From: Kristen Kapelanski, AICP
 Date: 3/23/2020
 Re: **Auburn Pharmaceuticals (City File #20-003)**
Site Plan - Planning Review #2

**Subject: File No. 20-003 Auburn Pharmaceutical;
Wetland Use Permit Review #2;
Plans received by the City of Rochester Hills on
March 11, 2020
ASTI File No. 9675-94**

From: Jason Boughton, AC, Engineering Utilities Specialist
To: Kristen Kapelanski, AICP, Planning Manager
Date: March 25, 2020
Re: **Auburn Pharmaceuticals, City File #20-003, Section 21
Site Plan Review #2**

CITY OF ROCHESTER HILLS STANDARD DETAIL FOR: Sight Distance Pathways					
DRAWN BY: B. SMITH	FILE NAME: CIRC DRV	PLAN DATE: 8/28/1996	REV. 4/12/2012	REV. 3/15/2014	REV.
APPROVED BY: PAUL SHUMEJKO, P.E., PTOE CITY TRANSPORTATION ENGINEER			NOT TO SCALE		SHEET 2 OF 2

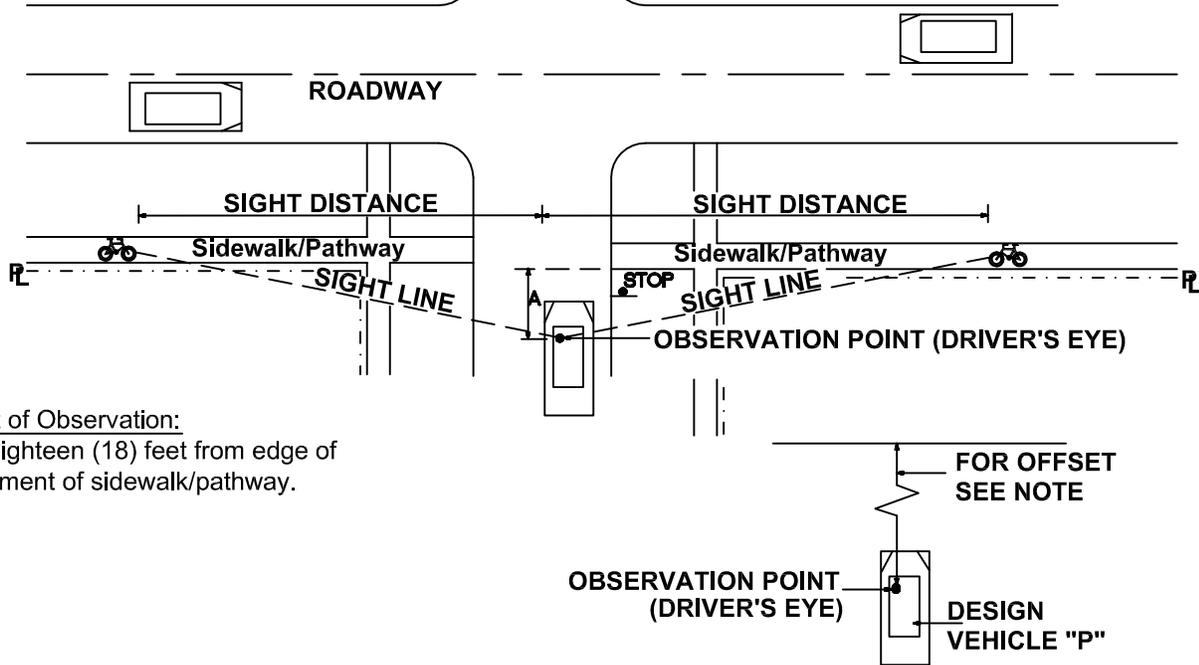
1. Per City Ordinance and/or Planning requirements, a sidewalk is required across the entire frontage. Therefore, it is preferred to obtain a variance to this affect. Please coordinate with Kristen Kapelinski regarding this comment.
2. The sidewalk sight lines are not shown on the Landscape Plan, sheet L2. Please revise per City detail attached.
3. It is understood the sidewalk connection to Clinton River Trailway is not preferred due to security reasons. However, some type of agreement and indication on the site plan should state that future connection to the East or proposed Rochester Hills Research Park development trailway connection would be made once their site build out is complete.
